Re: Hope Christian Elementary School Addition (Tract 23, NAA – D18/D009A)

Re: Hope Christian Elementary School Addition, Lot 23, Grading and Drainage Plan

Engineer's Stamp dated 8-30-10 (D18/D009A)

DRAINAGE FACILITIES WITHIN CITY RIGHT-OF-WAY

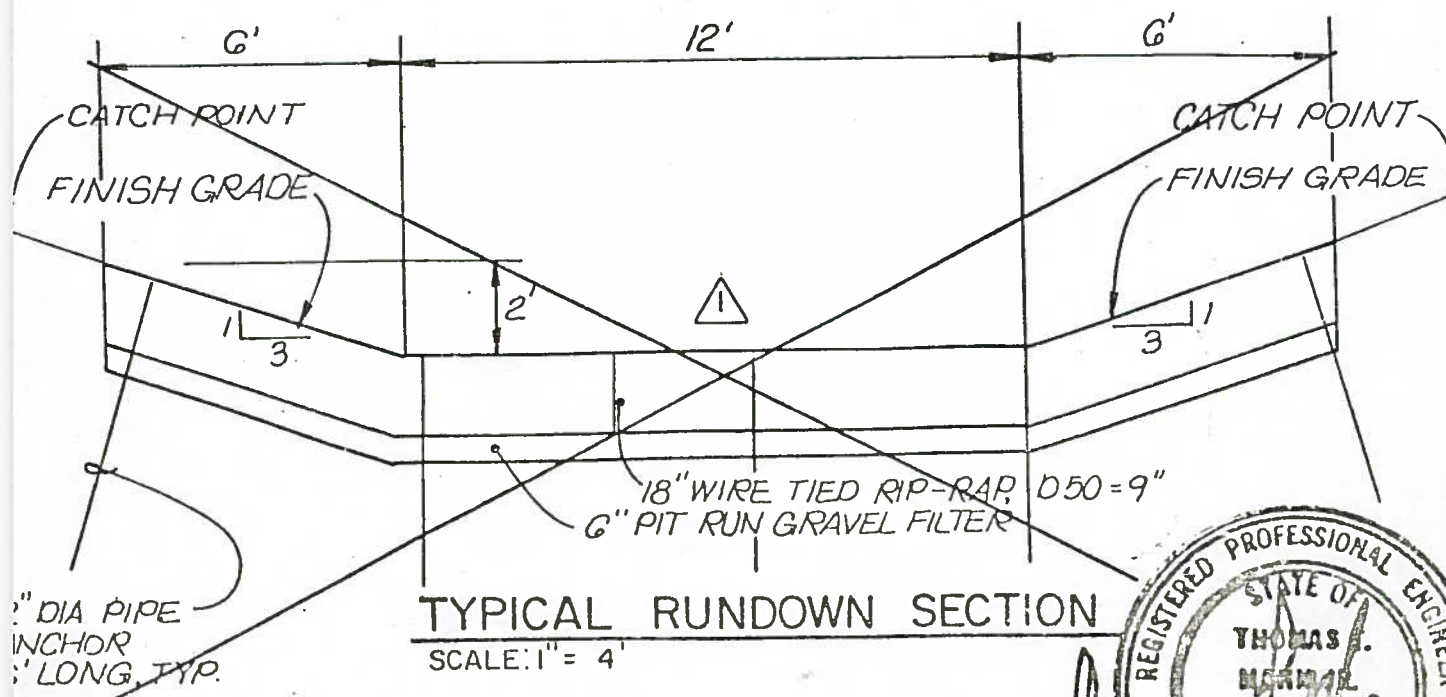
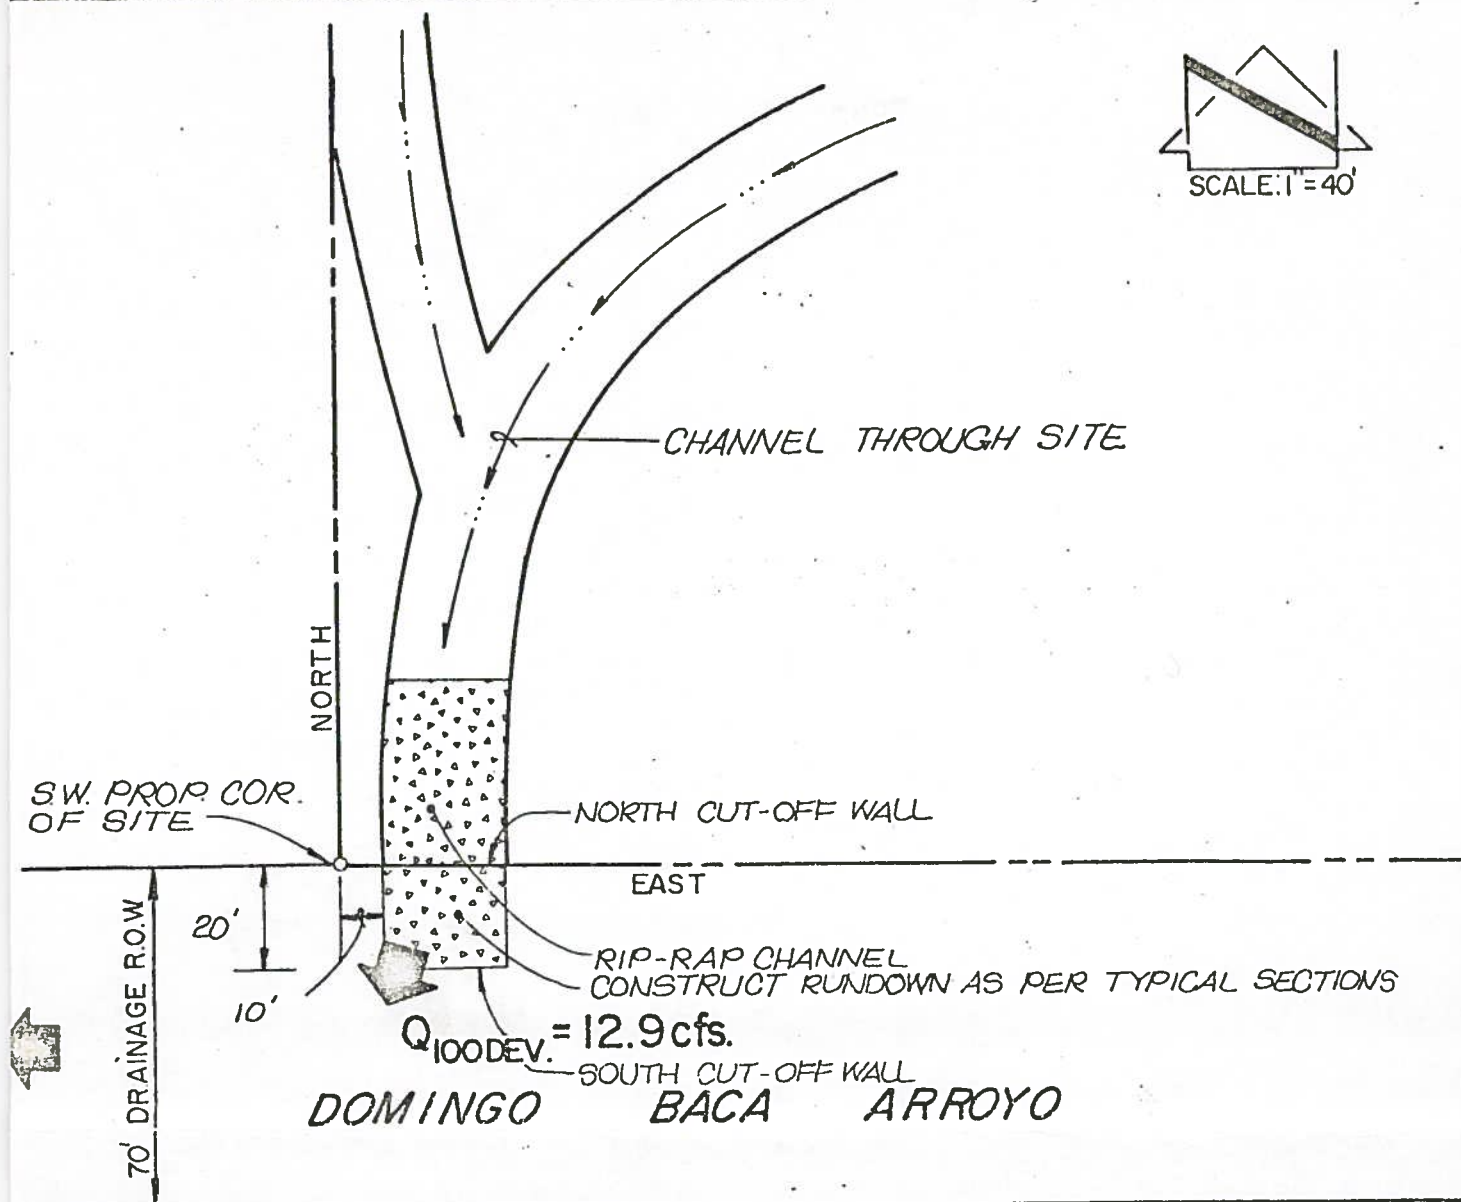
8/20/82		DELETE "TYPICAL RUNDOWN SECTION"		JGM	P.T. 0/27	62	
DATE		REMARKS		BY	APP'D.		
APPROVALS		NAME		DATE		TITLE: 6800 PALOMAS AVE. N.E. HOPE HIGH SCHOOL DRAINAGE RUNDOWN	
C.E. / DESIGN		<i>P. K. Kitch</i>		11/11/82			
SPECTOR		<i>D. D. D.</i>		10-7-82			
E. / FIELD							
				PERMIT NO.		MAP	
				SHEET 2 OF 3		NO. D-18
